Re: Land adjoining Green Meadow, Pilot Street, St Dogmaels.

Response from St Dogmaels Community Council

Response from St Dogmaels Footpath Association / Llwybrau Llandudoch

1. Photo of location of the stream between Avondale and Castle View that is culverted under Pilot St. onto the development site.
2. Photo of water flow in stream between Avondale and Castle View
3. Photo of the manhole with the roadside view of the stream between Avondale and Castle View

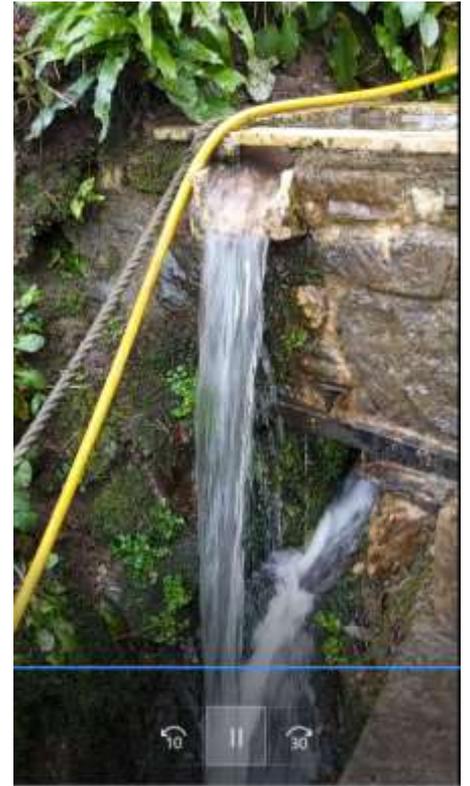
- c) As evidence, attached are 2 photos, one of the location of the stream between Avondale and Castle View that is culverted under Pilot St. onto the development site and a second of water flow in stream between Avondale and Castle View

- d) Also attached is a picture of the manhole with the roadside view of the stream immediately behind.
- e) Some water courses were clearly identified by St Dogmaels Community Association when managing the invasive species Himalayan Balsam which spread from gardens above Pilot St, through culverts under Pilot St into a ditch on the Southern edge of the development site and also on a more northerly route through the site to the Teifi cliff face.
